DATE: June 14, 2024
TO: ALL PLAN HOLDERS OF RECORD
FROM: HUNTER SWATEK, AIA, PROJECT MANAGER
PROJECT: RAINBOW CITY RECREATION CENTER
GMC PROJECT NO. ABHM230021
RE: ADDENDUM NO. 2 AND
ACKNOWLEDGEMENT OF RECEIPT OF ADDENDUM NO. 2

ADDENDUM NUMBER 02

**PROJECT: RAINBOW CITY RECREATION CENTER
GM&C PROJECT NO. ABHM230021**

A5 WEST ELEVATION
SCALE: 1/8" = 1'-0"

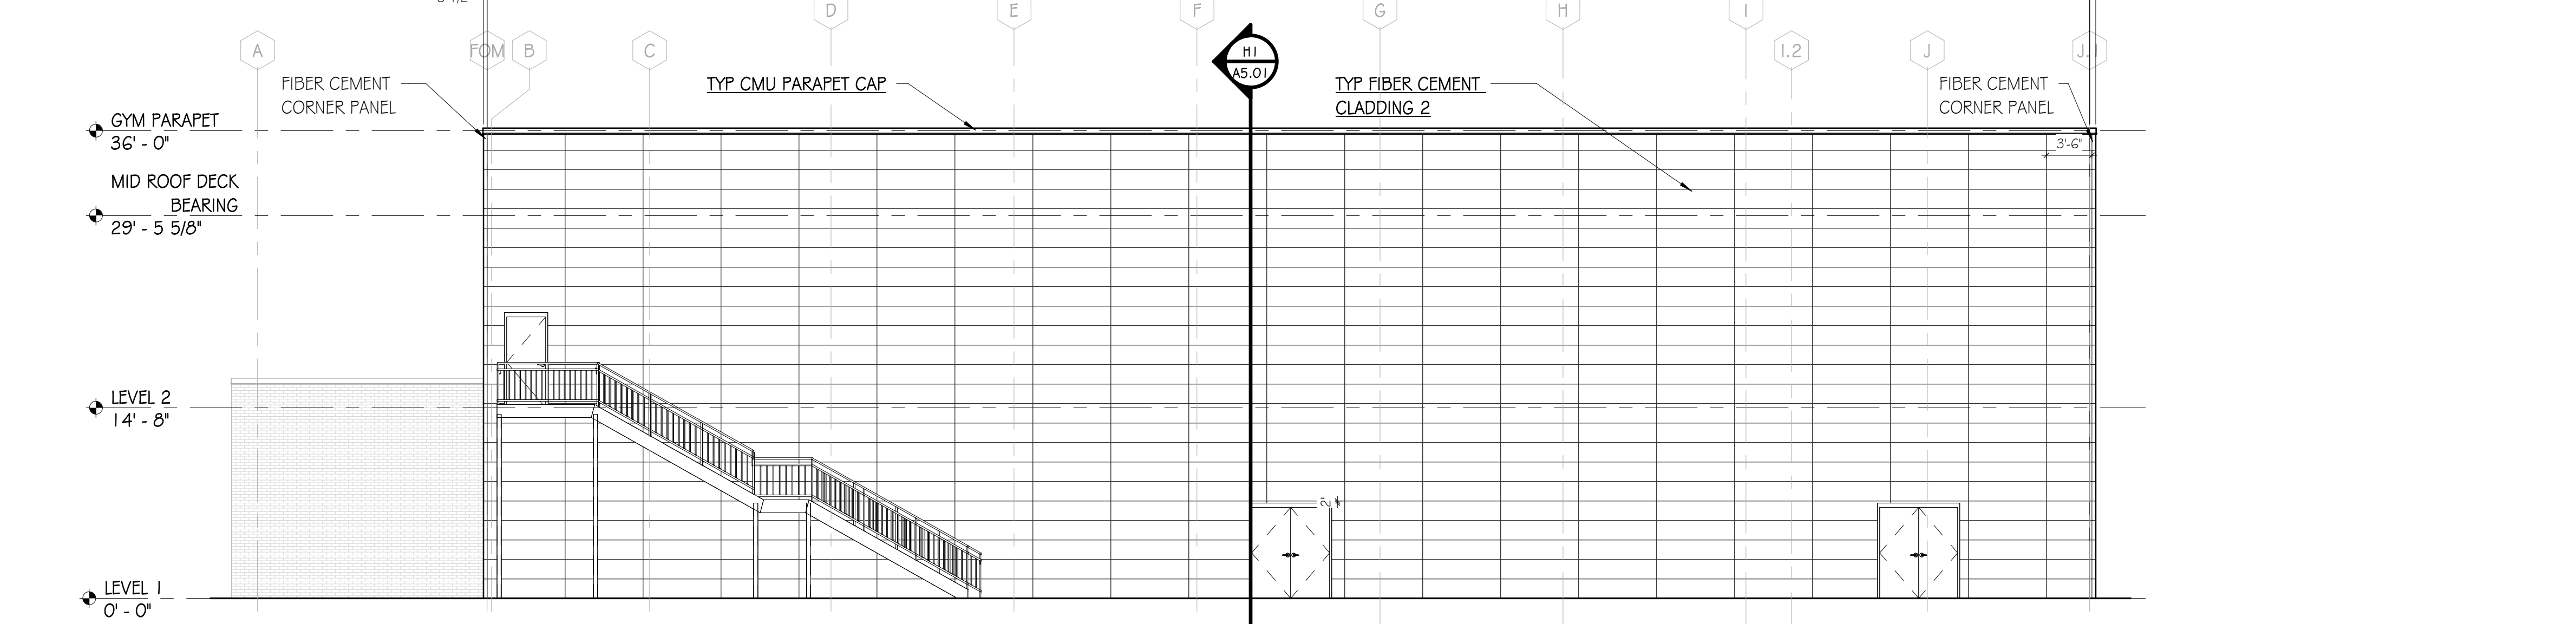
- D. **A3.03** Roof Details
 - a. REVISED Blocking
- E. **A4.01** Exterior Elevations
 - a. REVISED Fiber Cement Panel Pattern / Placement
 - b. REVISED Parapet Overflow Nozzles

DOOR SCHEDULE,
 LEGEND, & NOTES

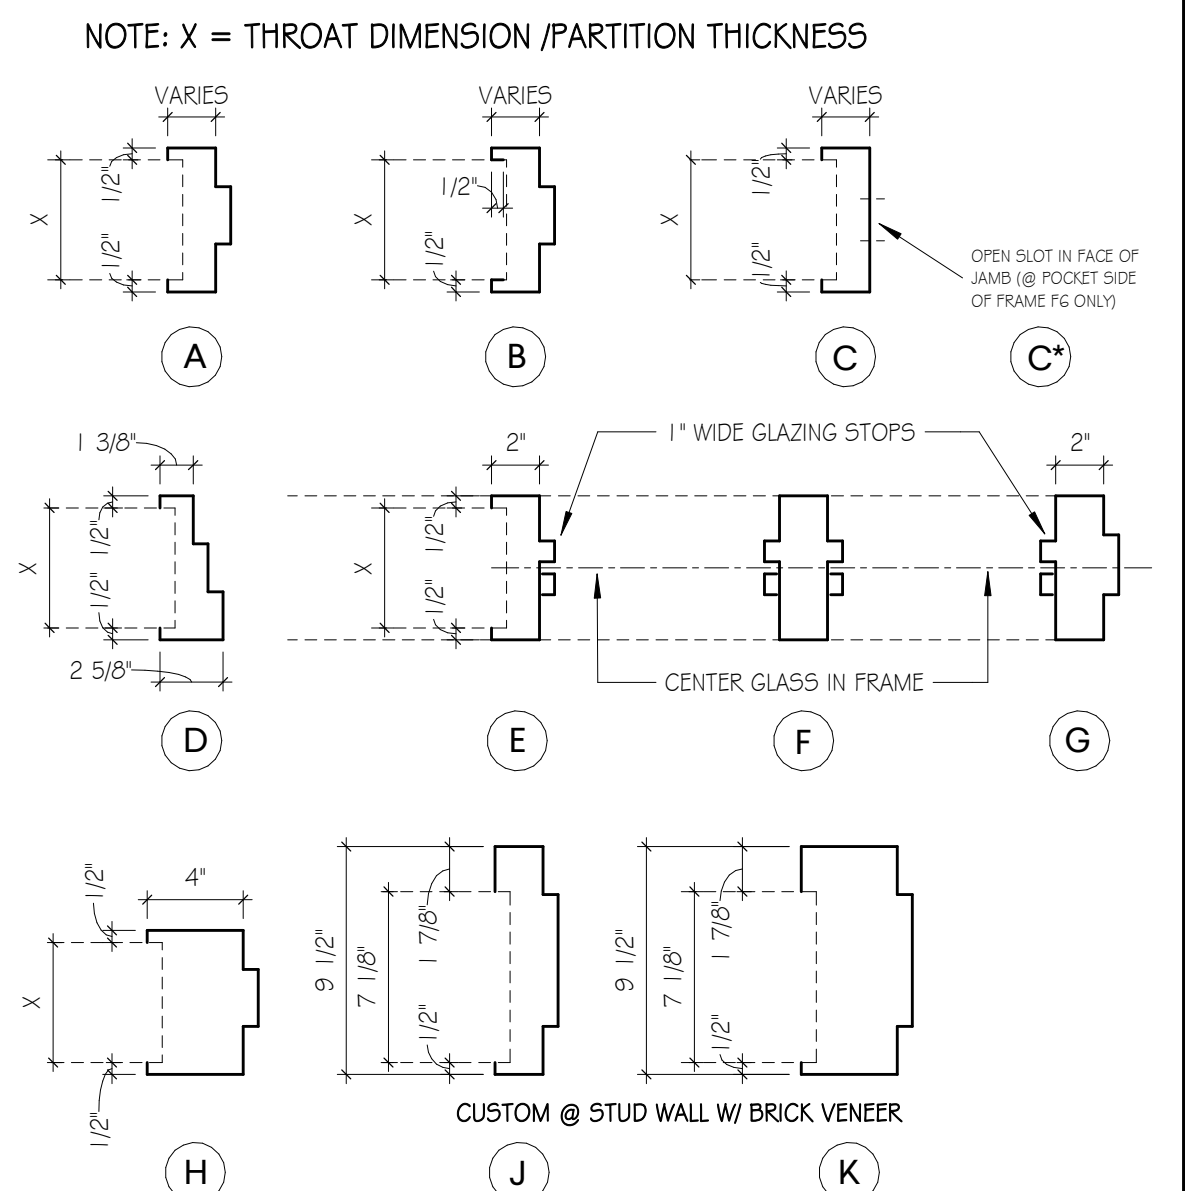
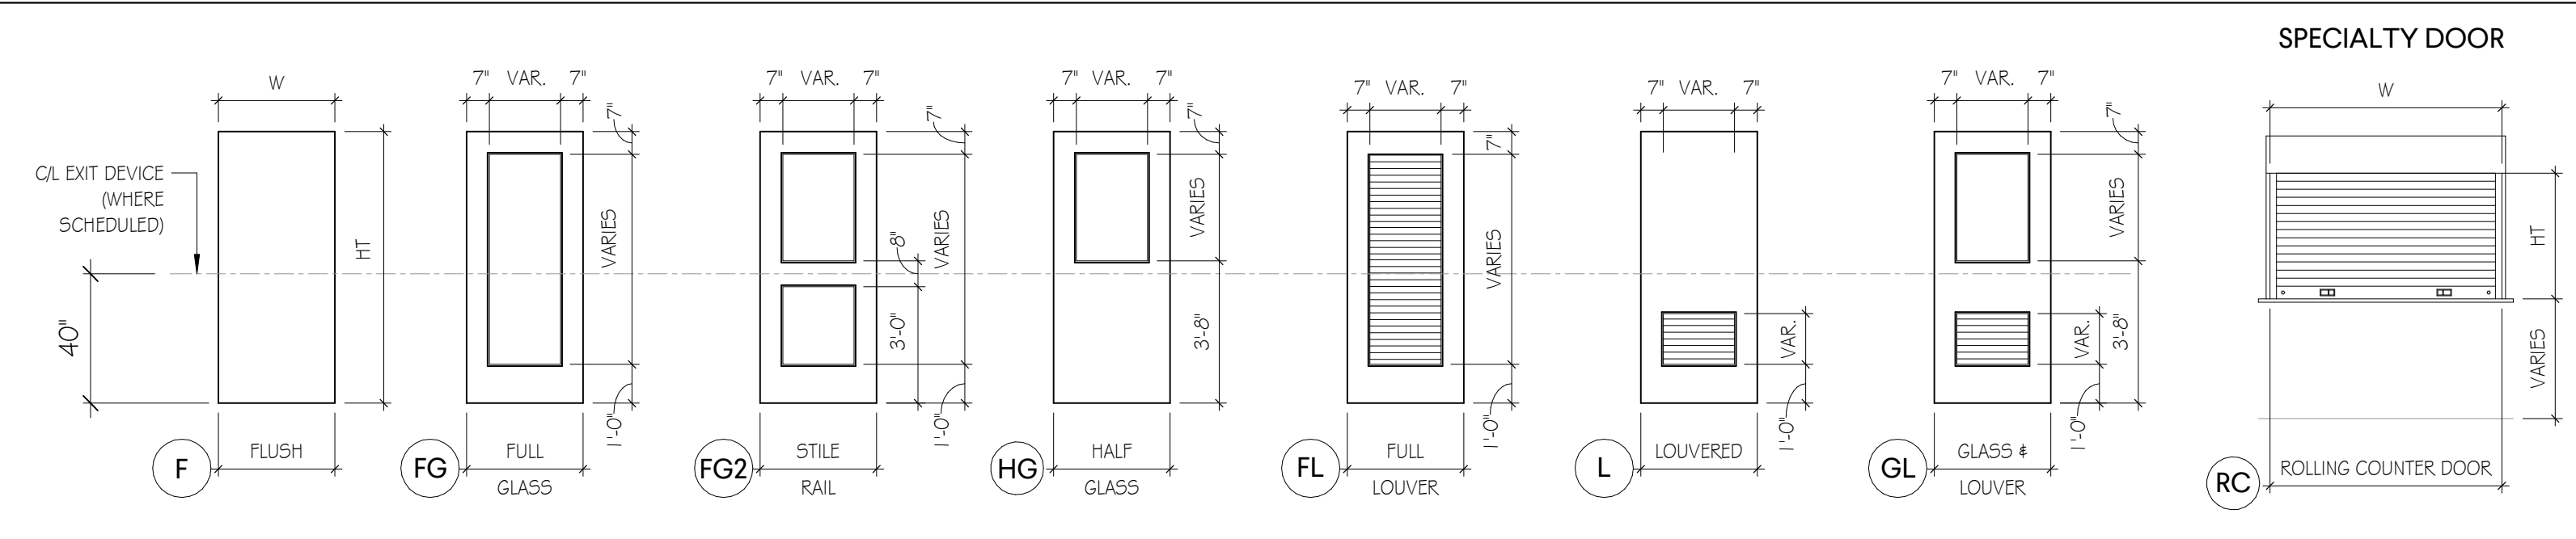
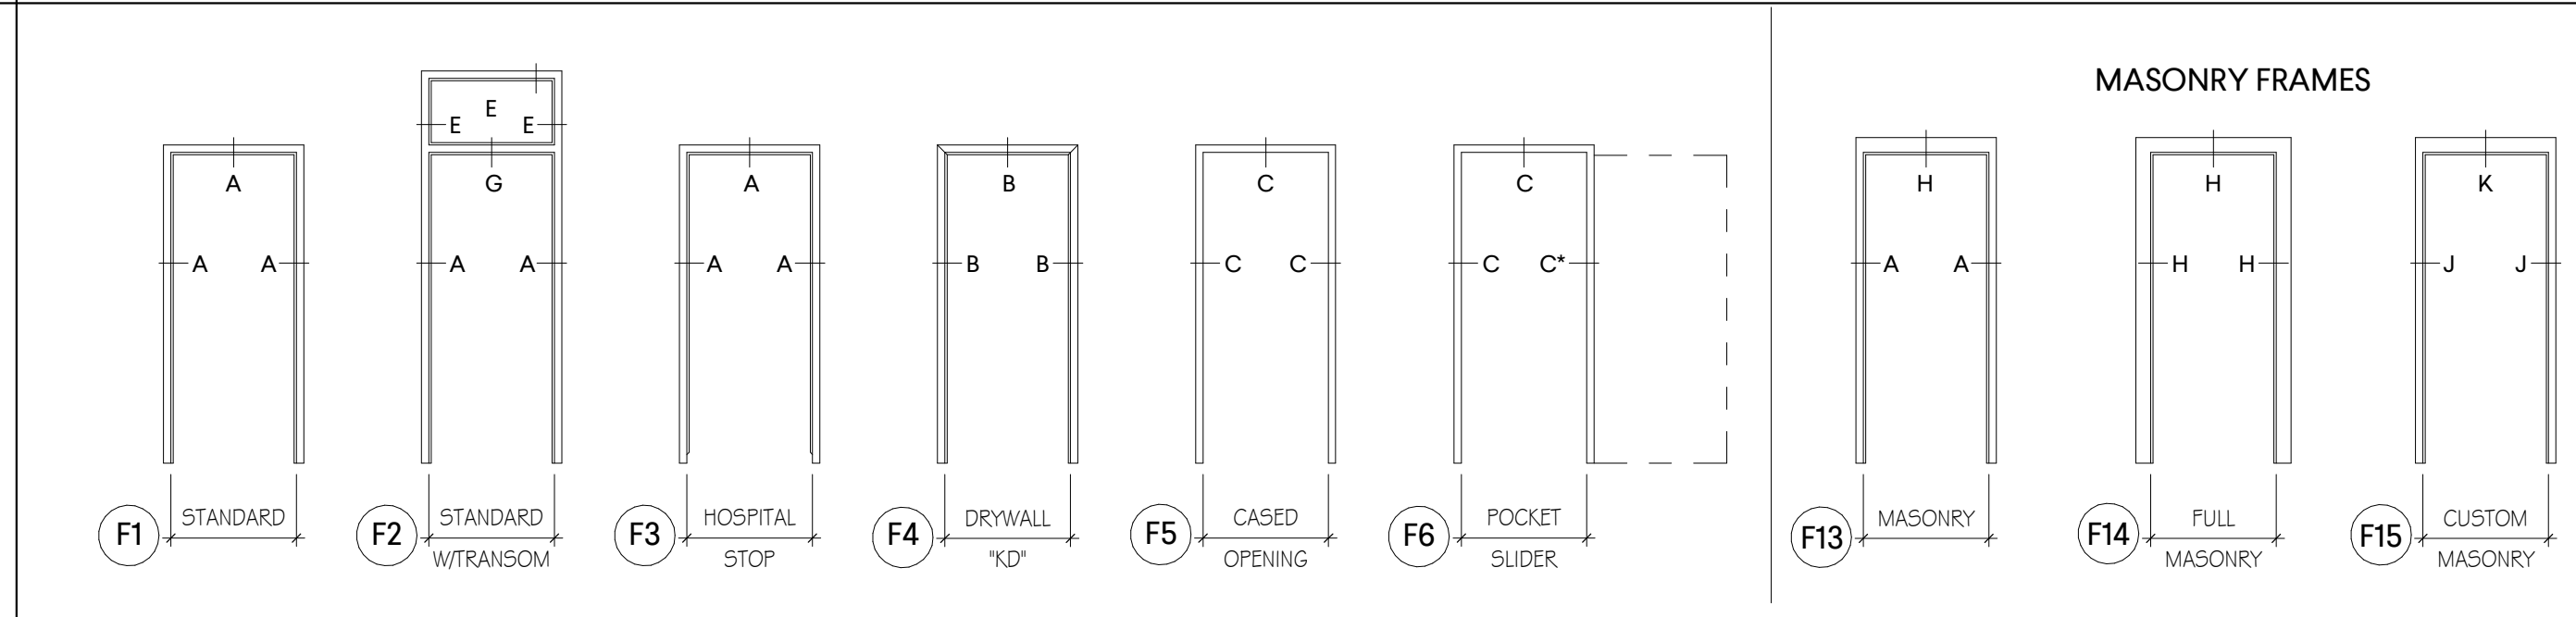
- F. **A6.01** Door Schedule, Legend, and Notes
 - a. REVISED Hardware Set No.
- G. **A6.02** Door Details
 - a. REVISED Detail Notes
- H. **A6.13** Curtain Wall and Storefront Details

| Question | ADD # | Response |
|---|-------|---|
| Doors 131 & 203 are missing on the hardware set. Is it understood to apply to opening 131 to "2" and opening 203 to "1" | 2 | See Revised Door Schedule A6.01 |

- E. **Section 08 7100** Door Hardware
 - a. Page 16 of 26
 - i. ADD to Hardware Set: 05, Door Numbers 131 and 206
- F. **Section 22 0440** Plumbing fixtures
 - a. Paragraph 2.6, K
 - i. REVISED LAV-3 to LAV-2
 - ii. ADDED SH-3 Outdoor Shower
